The funicular planning application (3) – how can it be valid when access tracks omitted?

This post takes a look at the scope of Highlands and Islands Enterprise’s planning application ([see here for papers](#)) to repair the funicular, its proposals for accessing the areas where they say work is required and the impact that this will have on the natural environment.

Fig 3 – Mid-compound layout utilising existing shieling for welfare  
(Extract from Drg no CS19035C007-T)

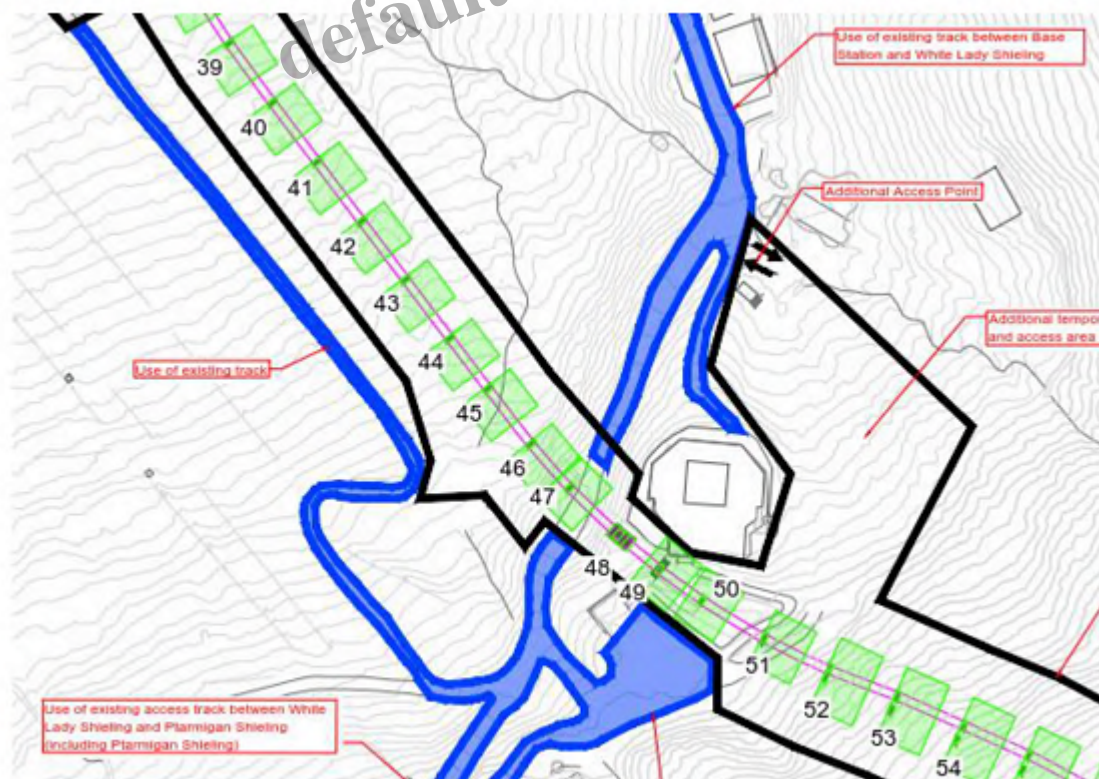
Extract from site plans for area around the Shieling. The green blocks the areas that HIE claims require planning permission, the black line the boundary that HIE says will be affected by the works and the blue access tracks. The Shieling tow access track is the blue line on the left.

The working area – where vegetation and soils may be affected and machinery may be driven – is clearly much larger than the 0.98 hectares around the pillars included in the Planning Application.

What's more, besides the area marked in black, the application states that *“existing access tracks will be heavily used.....upgraded where necessary and maintained in the current condition”* and that *“additional temporary”* tracks will be constructed to connect the existing access tracks to the working area. To take the example of the Shieling track:

What this means is that HIE is claiming that they don't need planning permission either to upgrade the Shieling track or to install three new temporary tracks to connect it to the working area.

View up the Shieling Track

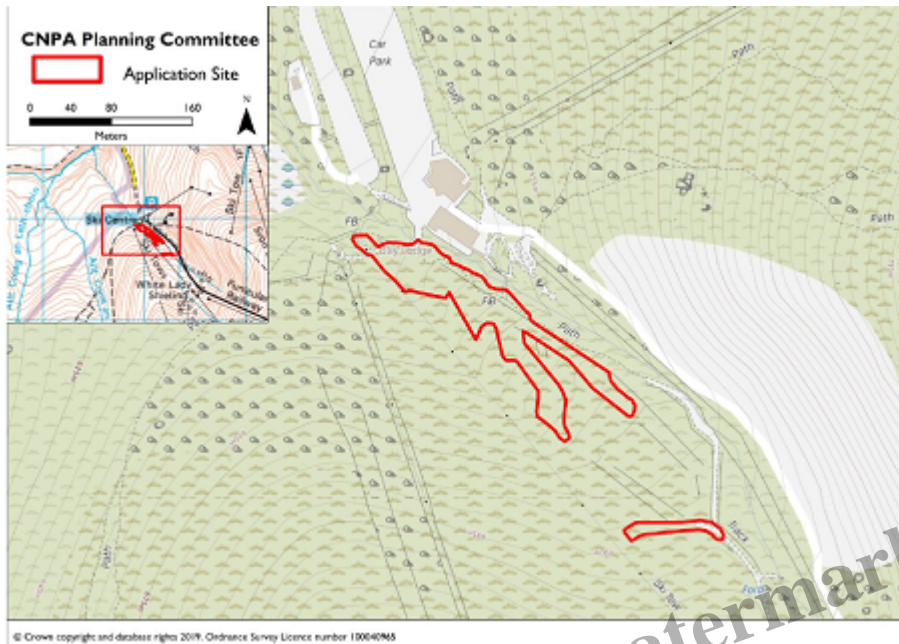
No evidence has been provided to suggest that the Shieling Hill track, which was granted retrospective planning permission in 2017 ([see here](#)), can withstand “heavy use” while being maintained in its current condition. The history of this “track” is that it was not constructed as a track at all, but created after the Shieling Rope tow had been installed because Natural Retreats had failed to retain sufficient vegetation to restore the area as originally required. To adapt it for heavy use will require significant

upgrading work. In similar cases elsewhere, the CNPA has for the last couple of years been rightly forcing the landowners to apply for retrospective planning permission, as in Glen Banchor ([see here](#)) and Glen Clova. So why has the CNPA now allowed HIE to lodge this application without the tracks being included?
